FINAL REPORT

Review of Crude Oil Storage Tank 2 Out-of-Service Inspection Documents

PWSRCAC Contract # 5081.22-01

May 2024

Figure 3 – Tank 2 Annular Ring CP Ground bed Design

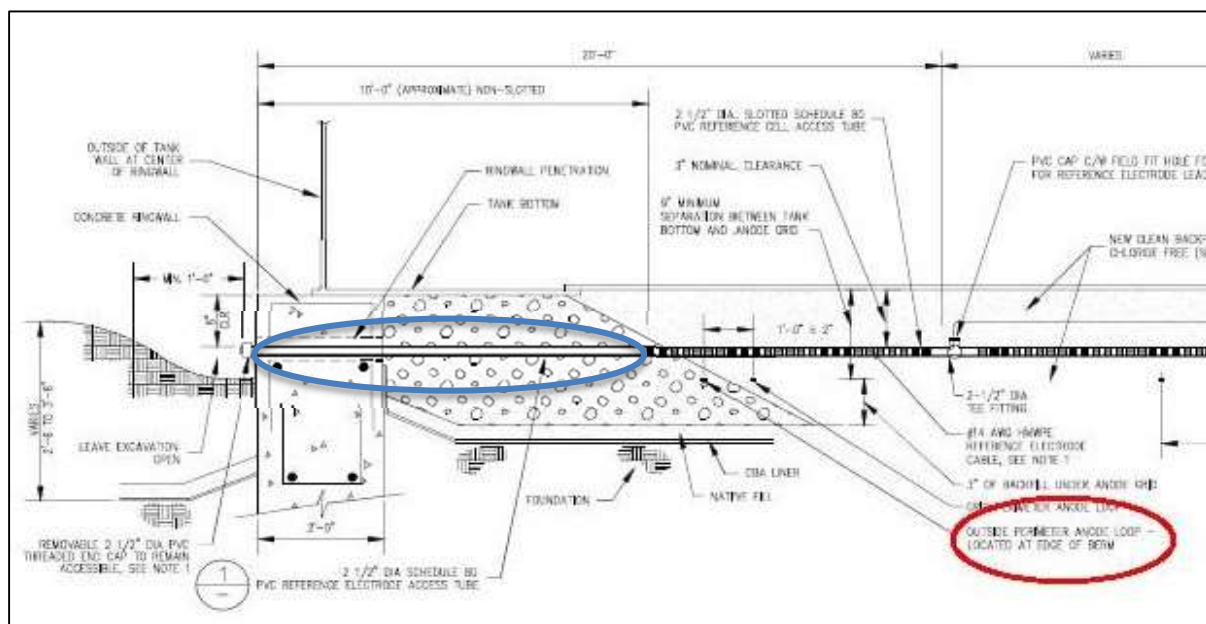
The ground bed for the Tank 2 CP system consists of an MMO grid distributed throughout the area beneath the tank floorplate. The CP design includes a separate MMO loop intended to protect the tank's annular plates. However, in that design, the annular ring MMO loop is located beneath the floorplate and does not extend to the annular plate (red circle in Figure 3). It is located more than 10 feet from the tank shell and more than 3 feet from the innermost edge of the annular plate (see Figure 3, excerpted from drawing D-54-E806). Figure 3 also indicates that the CP monitoring tubes beneath the annular ring are not slotted for the first 10 feet (blue circle in Figure 3), negating the ability to monitor CP below the annular plate and outermost 3 feet of floorplate (also referred to as sketch plates).

- 1) The MMO loop intended to protect the annular plates will distribute current primarily via the lowest resistance pathways. However, the annular plate and floorplate are welded together, and are therefore electrically continuous. As such, assuming similar backfill resistivity and the flow of current on the lowest resistance pathways, the CP current intended for the annular plate will go to the closest steel, which is the regular floorplate steel. This means that insufficient CP is being provided to the annular plate and sketch plates. Most of the current intended for the annular plate is going instead to the floorplate immediately above the outermost anode loop.

- 4) The MMO loop that is dedicated for the annular plate and perimeter floorplates (circled in red in Figure 3) is tied to a single circuit that cannot be adjusted independently of the

floorplate system. Even if the system had the ability to independently power the MMO loop nearest to the annular plate, the resulting CP current will go predominantly to the perimeter floorplate and will not measurably impact the annular plate.

- 2) The outermost 10 feet of the CP monitoring tubes are not slotted (circled in blue on Figure 3), which prevents the CP tester from monitoring the level of CP in that area. Slots in the monitoring tubes, allow the CP monitoring reference cell to make electrolytic contact to the soil beneath the tank floor. That enables the CP tester to measure the electrical potential of the floor above the monitoring tube. Based on the insufficient CP current to the perimeter area (as discussion in point 1 above) and the lack of a perimeter seal, the perimeter areas are least likely to be sufficiently protected from corrosion. The high concentration of corrosion damage in the perimeter areas that required repair in 2022, confirms that the CP levels are insufficient in those areas.

- The Tank 2 annular plate to ring wall seal should be replaced and maintained, or drip rings should be installed on the annular plate extension to prevent the ingress of water between the tank floor and secondary containment liner in order to mitigate corrosion and reduce corrosion rates.
- CP on the tank should be monitored in accordance with NACE SP-0193 and APSC’s internal procedure, MP-166-3.23 (which is based upon SP-0193).
- APSC should perforate the first 10 feet of the CP monitoring tubes for Tank 2 to facilitate CP monitoring of the tank annular plates and sketch plates.
- APSC should ensure that the 2022 Tank API 653 report and the 2022 Tank 2 Engineering Summary report provide consistent data and calculations

Figure 4 – Tank 2 CP System Perimeter Current Distribution

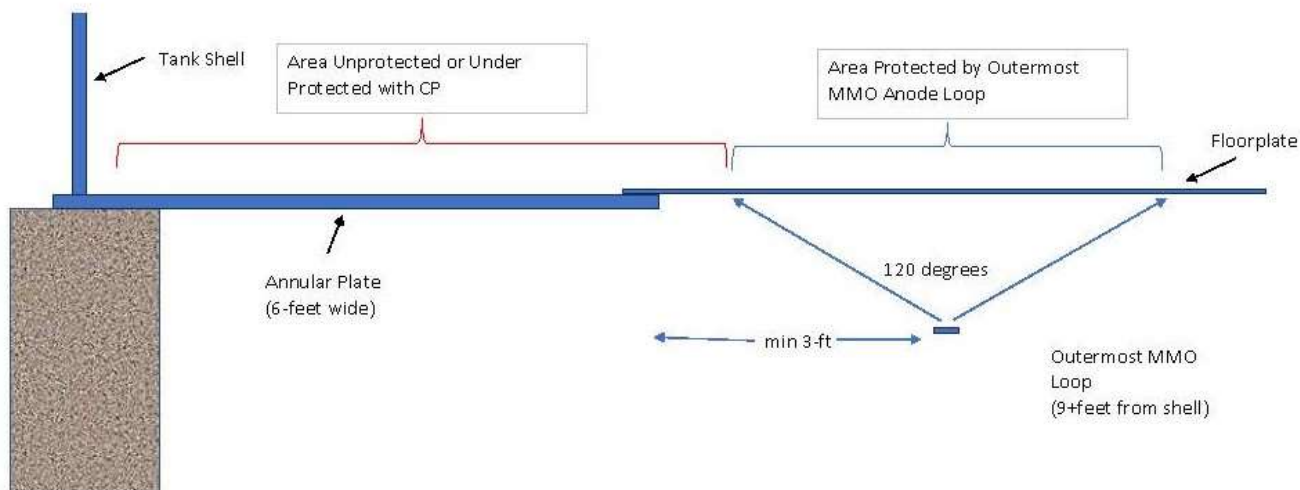
- 3) Finally, an industry rule of thumb used for designing ensuring uniform distribution of CP current for close coupled anodes, is to assume that the anode will distribute current to the steel surface in a (roughly) 120-degree arc of influence.² This rule of thumb is based on the resistance of the path length between the anode and structure. This is depicted below in Figure 4. However, as shown in the figure, the MMO loop intended to protect the annular plate will not provide protective current to the annular plate (also depicted in Figure 4) because the annular plate is beyond the 120-degree arc of influence from the CP system.
